SERVICETEKNOTES

TABLE OF CONTENTS

PS501-1 POWER SWITCH RELIABILITY IMPROVED (CONT.)

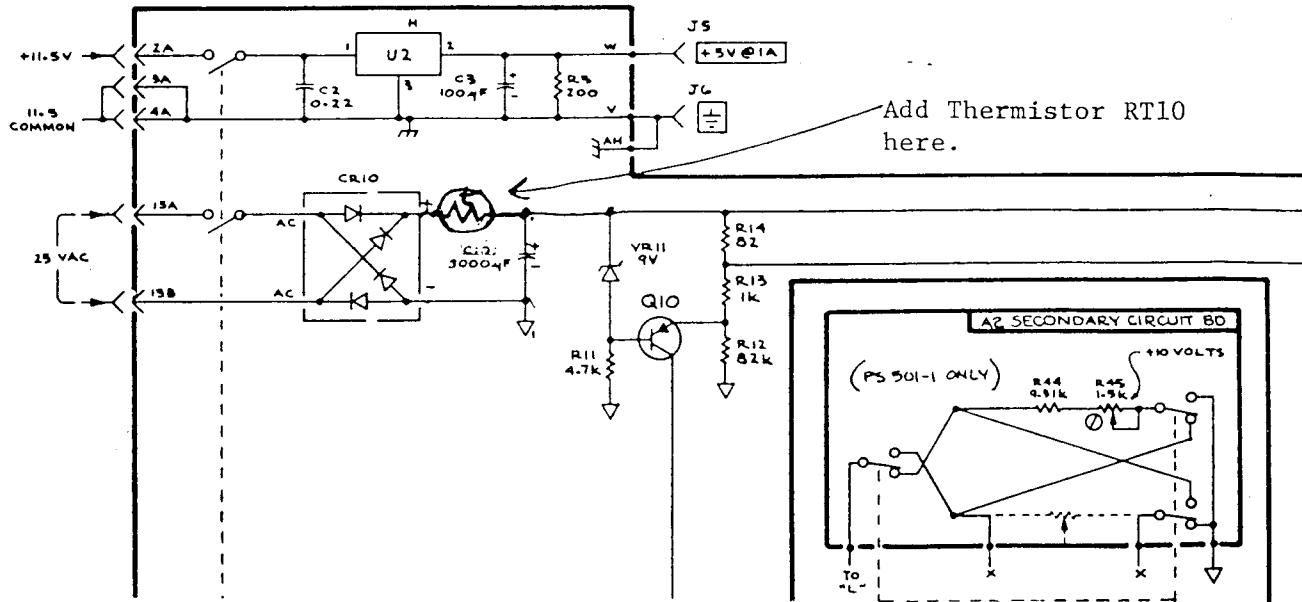
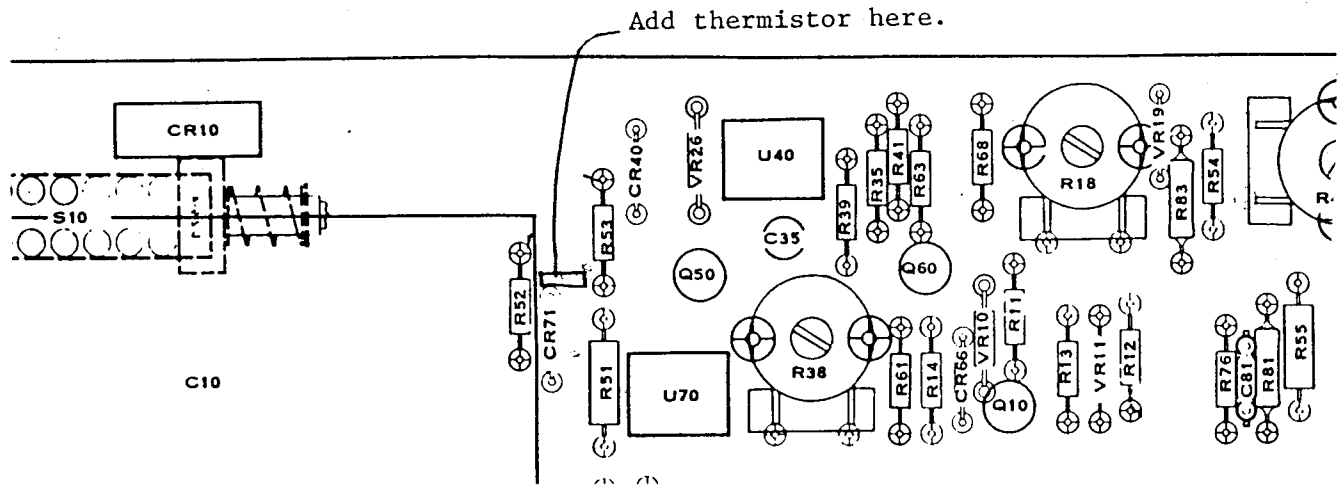
The reliability of the power switch S10 has been improved by reducing the surge current to C10 at turn-on. This has been done by adding a thermistor in series between the anode of CR10 and the positive lead of C10. The thermistor PN is 307-0746-00. This part is most easily installed by removing the upper bare wire attached to the plus terminal of C10 and replacing it with the thermistor. See attached drawings. This mod should be installed in every PS501-1 that is serviced.

Fig. 5-7. Equipment setup used to check TIM A-B accuracy.

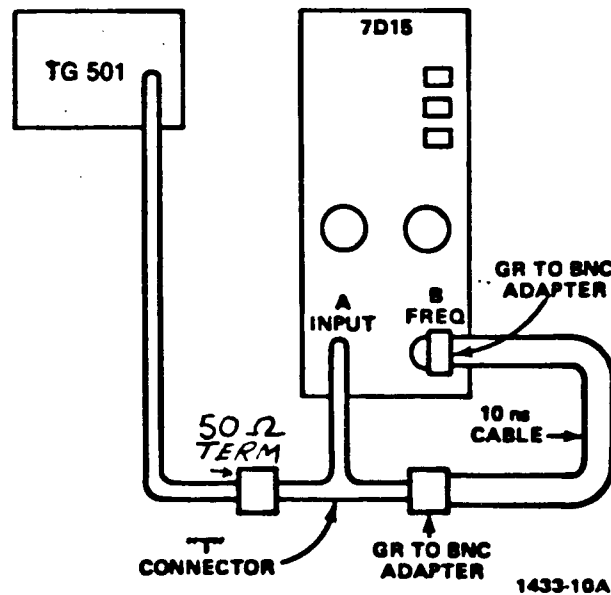
Step 13, Page 5-11, TIM WIDTH A AND TIM A to B ACCURACY

Delete entire step g.

Change step i to read: Check for decreasing gate time (indicated by faster flashing of gate light) and constant readout display of 10 ns \pm 1 ns as the TG 501 is switched from 1 ms to 10 μ s.

Delete item number 7 from the required test equipment. (Pulse Generator)

Change Figure 5-7 to the following:

Figure 1

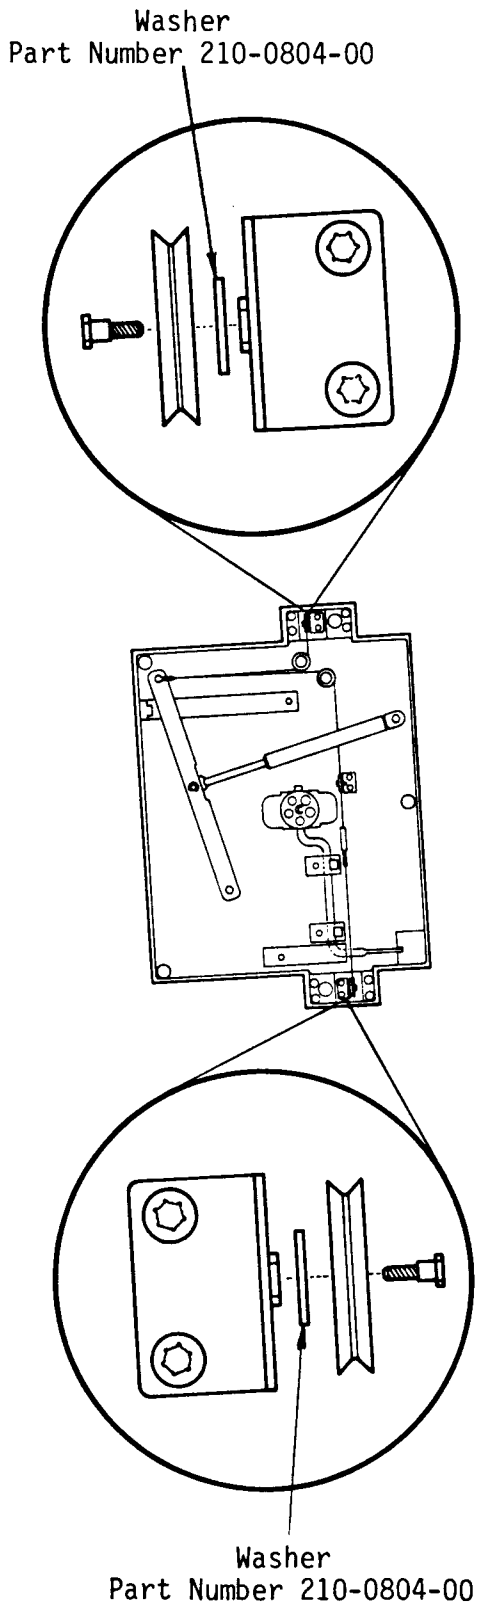
Several ADS01s have had trouble with two of the nylon pulleys pulling off at the bearing (refer to Figure 1). The problem has been identified, and a solution is available.

The solution is to add a 210-0804-00 (dimensions of washer .172 ID, .375 OD, and .30 thickness) steel washer between the pulley and mounting stud (refer to Figure 1).

Figure 1a.
Wire Harness for 118-0358-01, -02 and 118-1004-01

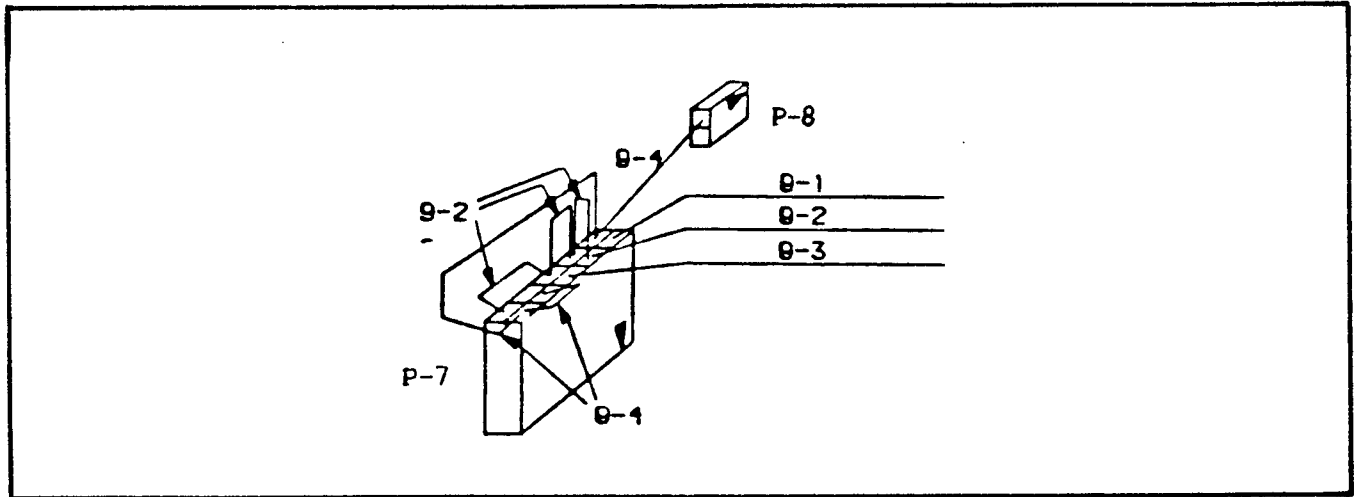
- 1) Place P-7 of this wire harness (shown in Figure 1a) on the board so connector pins 1 through 5 go over the square pins which connect to edge connector pins 2 through 10.
- 2) Place P-8 of the wire harness on pin set D of the board so the wire of P-8 is connected to the square pin which is toward the inside of the board.
- 3) Solder the 9-1 wire to the through hole connections to pin 3 of IC 2F.
- 4) Solder the 9-2 wire to the middle square pin of the NP/WP pin set.
- 5) Solder the 9-3 wire to the through hole located between ICs 3C and 3D (see Figure 4).

- 1) Place P-7 of the wire harness (shown in Figure 1a) on the board so connector pins 1 through 5 go over the square pins as shown in Figure 5.
- 2) Place P-8 of the wire harness on pin set D of the board so the wire of P-8 is connected to the square pin which is toward the inside of the board.
- 3) Solder the 9-1 wire to the through hole connecting to pin 13 of IC 4B.
- 4) Solder the 9-2 wire to the WP square pin of the WP/NP pin set.

Figure 2.
Wire Set for 118-1004-02

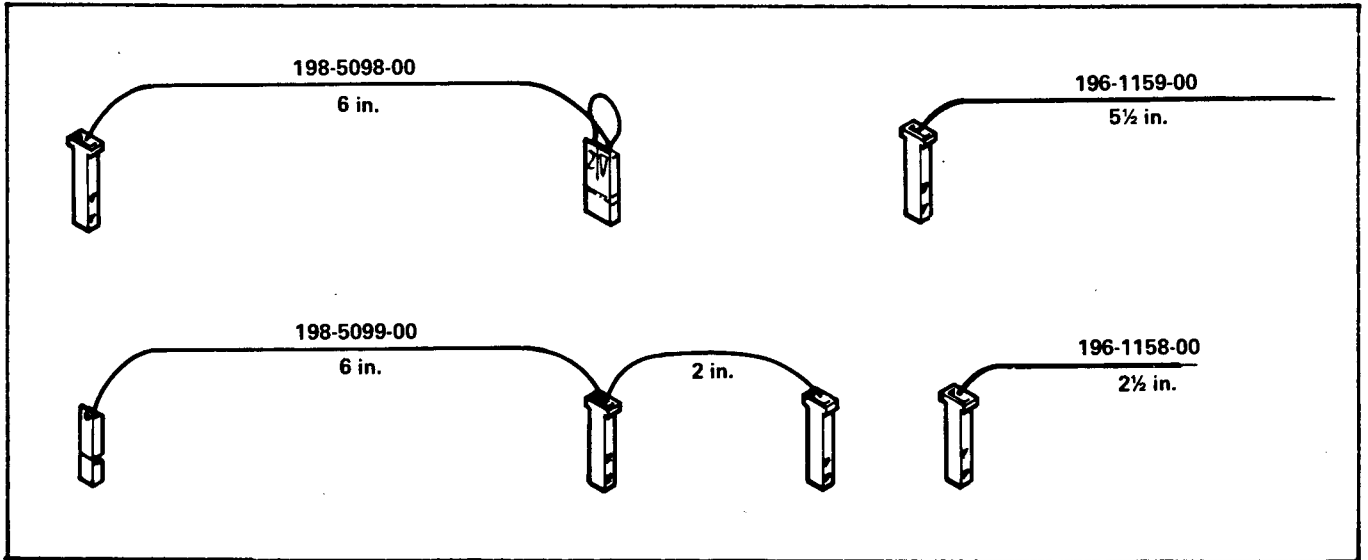
Refer to Figure 6 for locations of the wire to be attached in the following procedures. Refer to Figure 2 for description of the wires used in this procedure. Note that the 198-5099-00 wire is not used in the 4907.

- 1) Solder the stripped-lead end of the 196-1158-00 wire to the feedthrough connected to pin 13 of IC 2A.
- 2) Connect the other end of the 196-1158-00 wire to the square pin connected to Pin 6 of the edge connector as shown in Figure 3 below.
- 3) Connect the single-pin-connector end of the 198-5098-00 wire to the square pin connected to Pin 2 of the edge connector as shown in Figure 3.
- 4) Connect the other end of the 198-5098-00 wire (double-pin) to the square pin labeled Z of the Y/EZ/Z jumper so the other side of the double-pin connector is left open (not on a square pin).
- 5) Check that one end of the 196-1159-00 wire is soldered to the feedthrough connected to the WP side of the NP/WP square pads.
- 6) Connect the other end of the 196-1159-00 wire to the square pin connected to Pin 4 of the edge connector as shown in Figure 6.

Figure 4.
Board Layout for 118-0358-01, -02

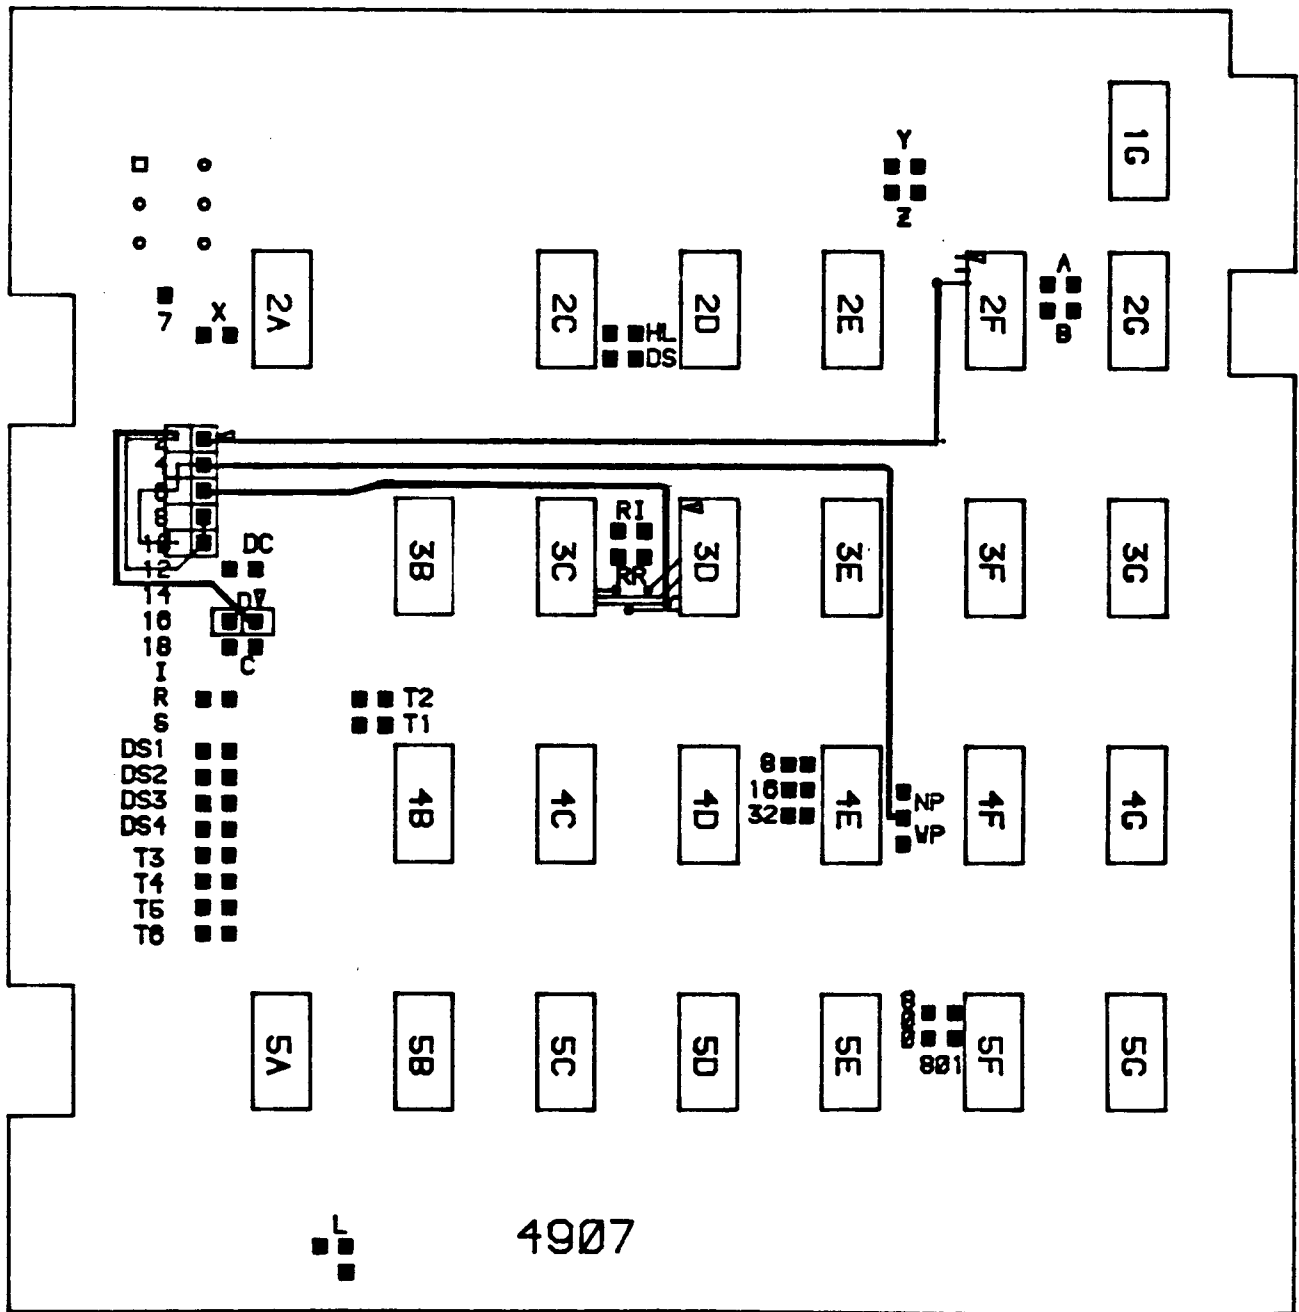
Refer to Figure 4 for locations of the wire to be attached in the following procedures.

Figure 5.
Board Layout for 118-1004-01

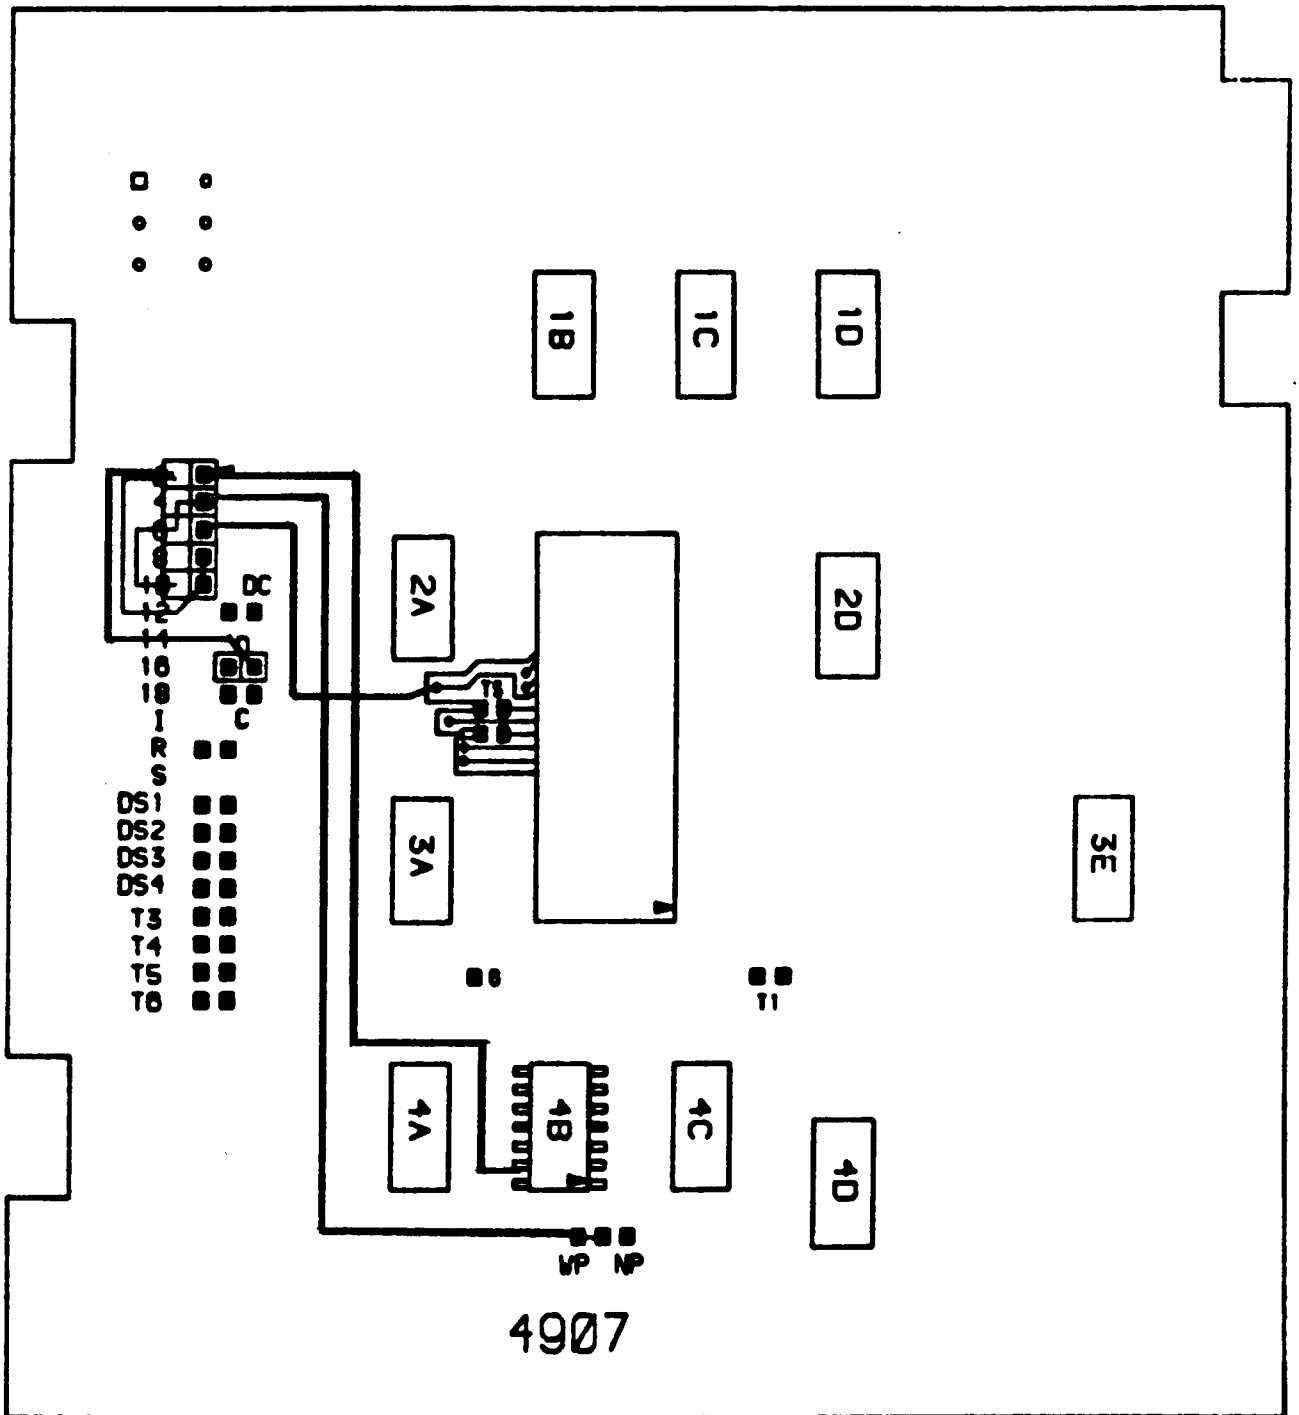
Refer to Figure 5 for locations of the wire to be attached in the following procedures.

- 5) Solder the 9-3 wire to the through hole located between ICs 2A/3A and the LSI IC as shown in Figure 5.
